# Plan Change Request

Site Address/ Parcel #: 0420331121 Permit #: PRCCP20241189  
Owner: Washington State Fair Email: marty@thefair.com  
Design Engineer: Justin Jones Email: justin@jmjteam.com  
Contractor: Mountain Construction Email: ken@mountainconst.com

➤ Specify the approved civil plans affected: C4-101, C4-103, C4-202, C6-101, C6-102, C6-106

Project:  
**Washington State Fair International Village Redevelopment**

DWG. No. **C6-102**

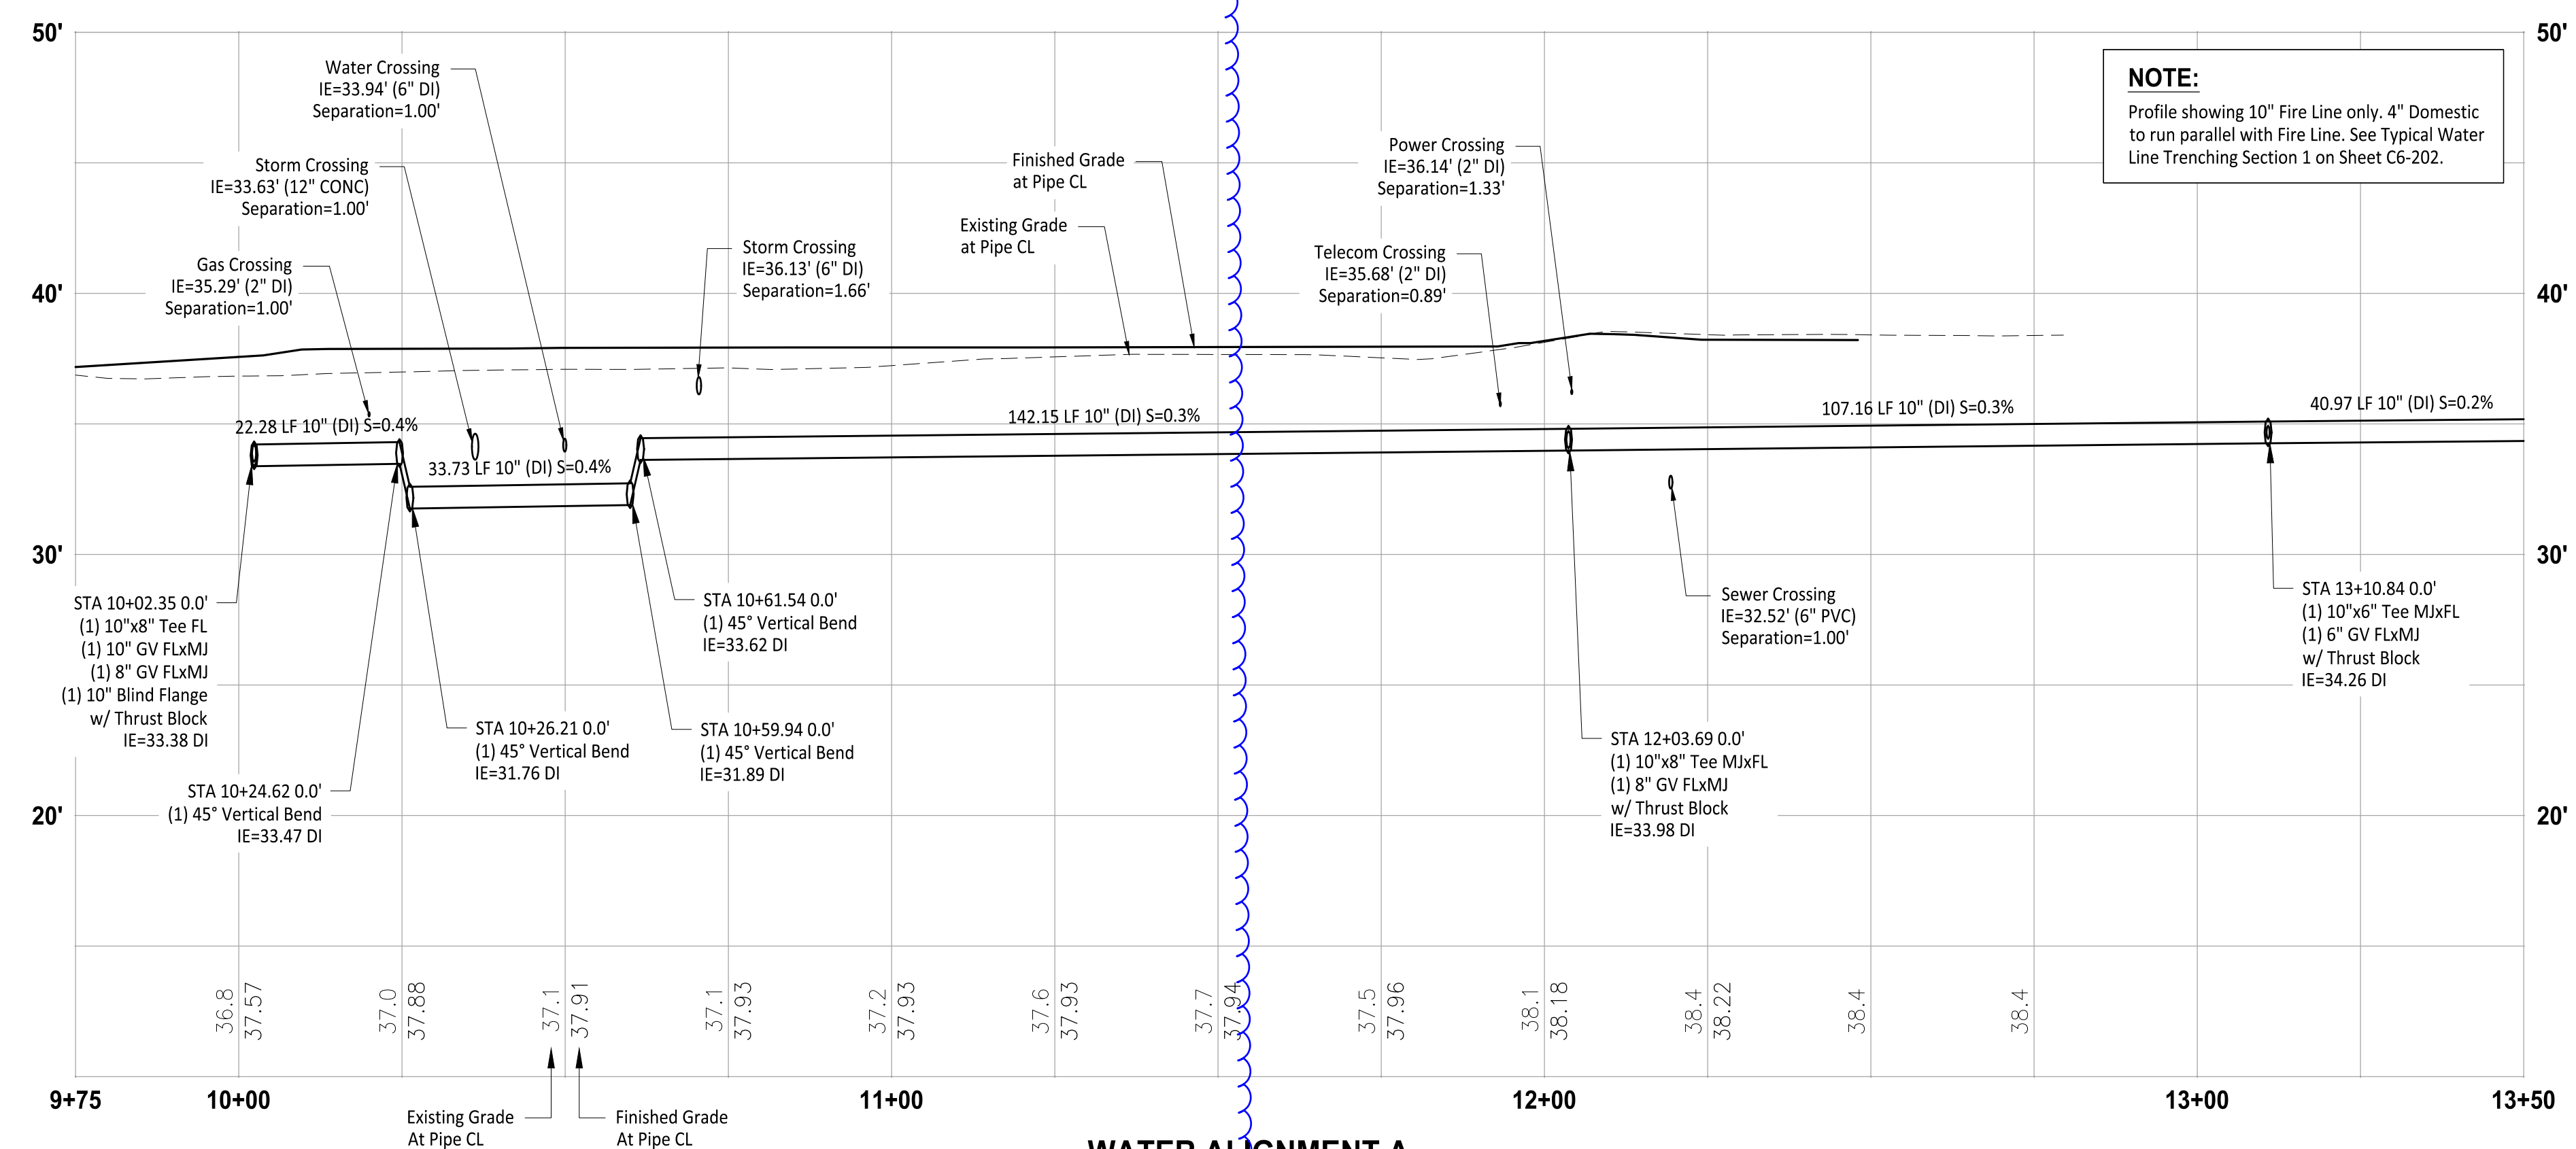
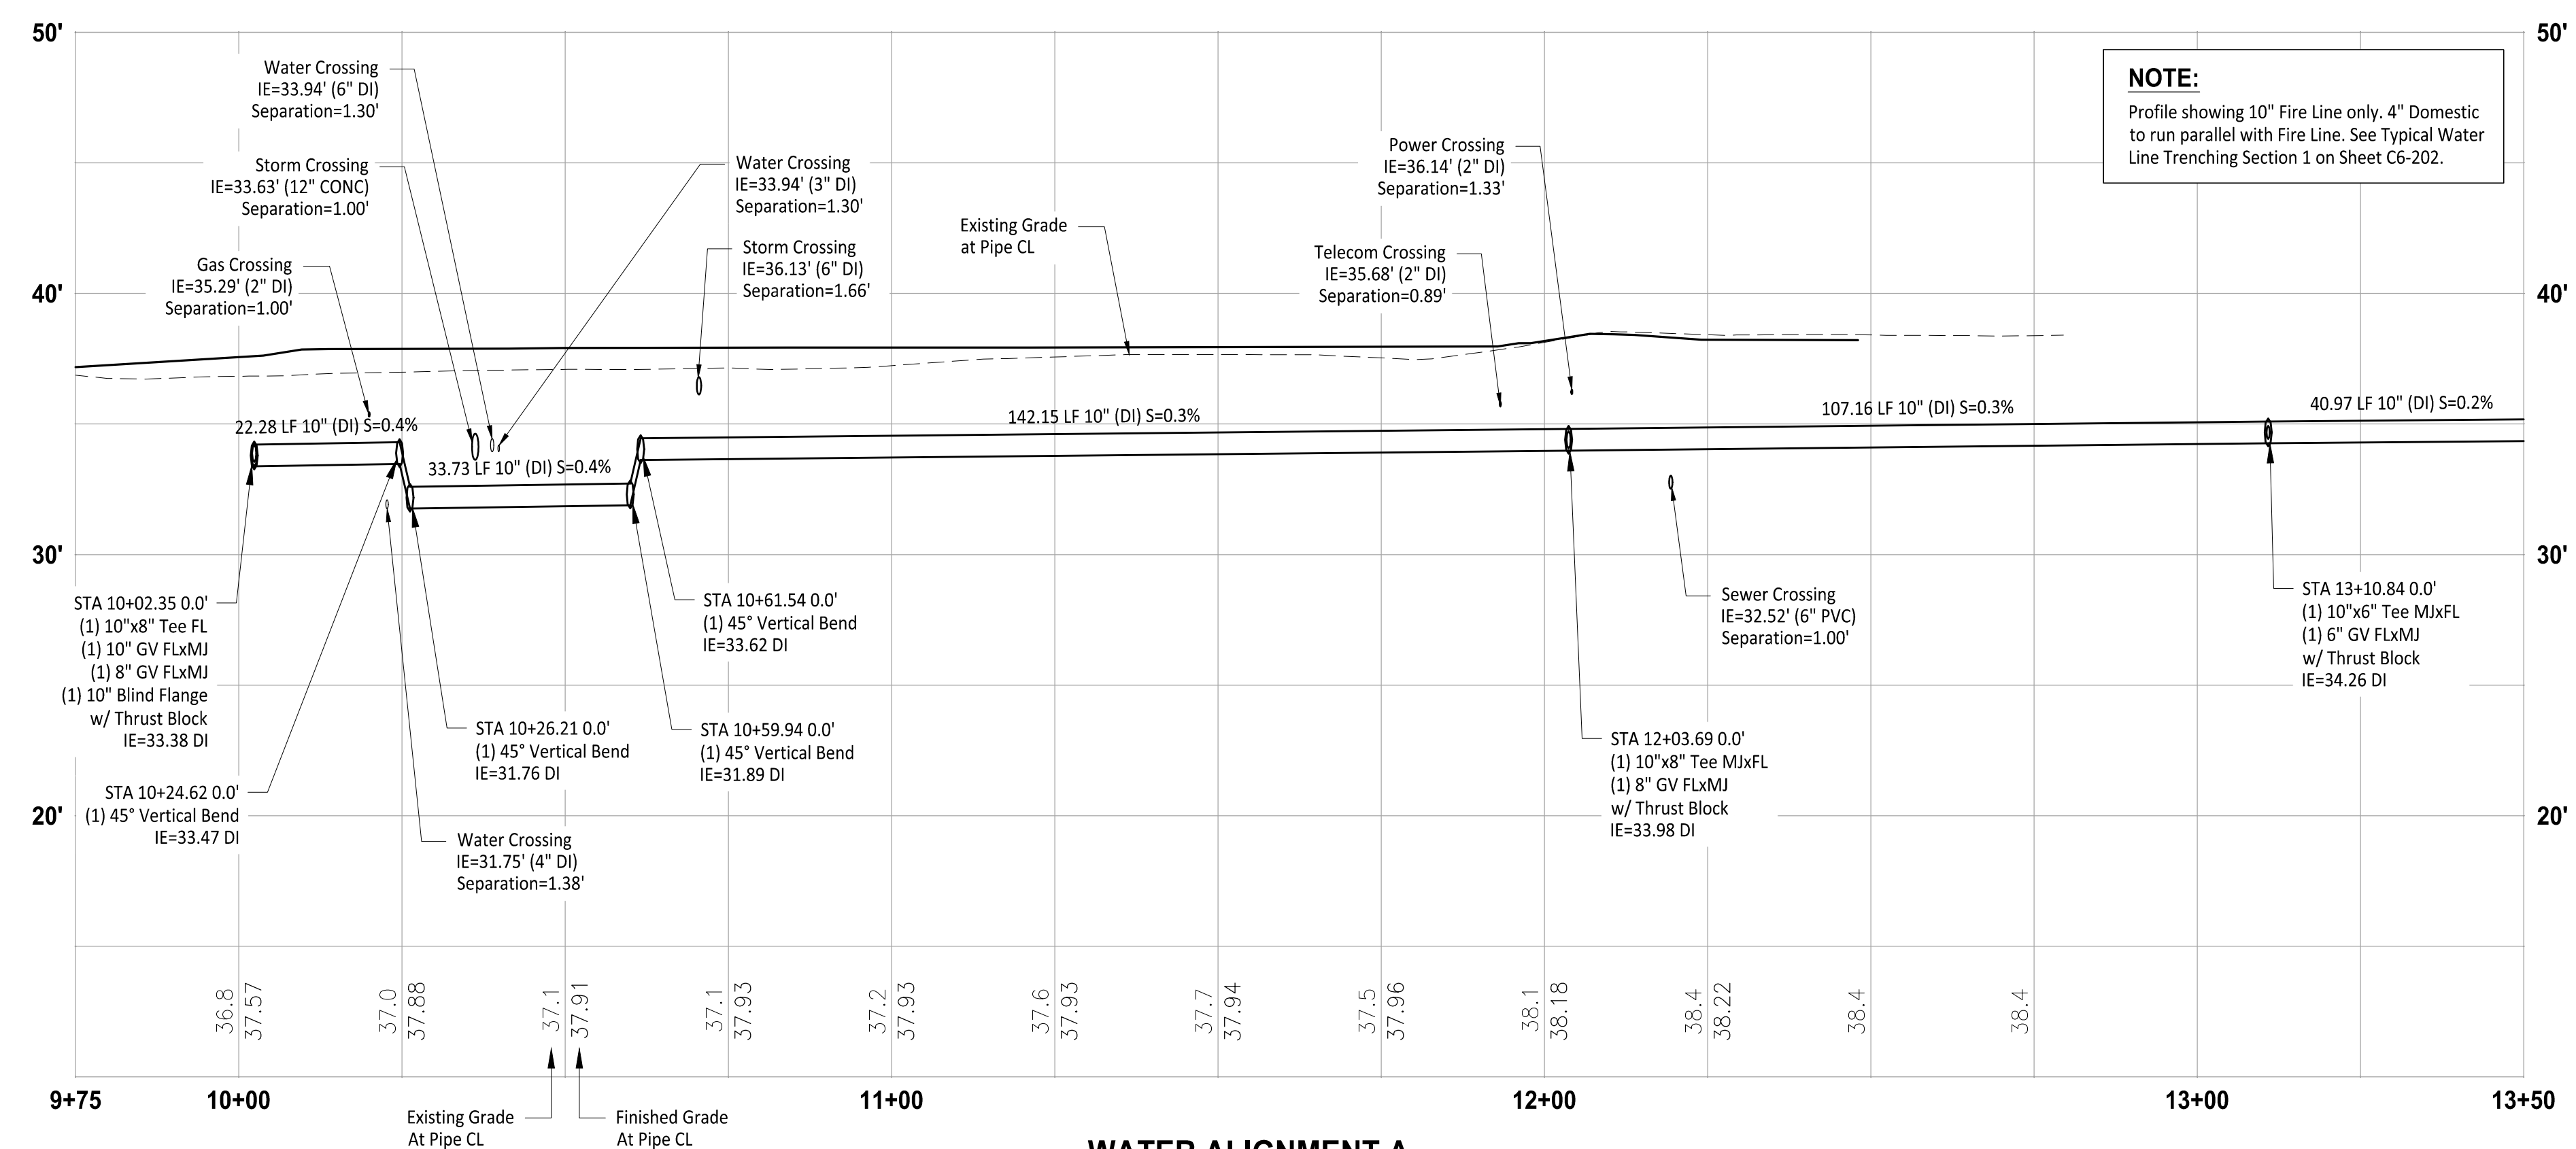
The RPBA has been moved from in front of the west side of the building to the field to the west. Subsequently, the location of the DDCVA will shift within the field.
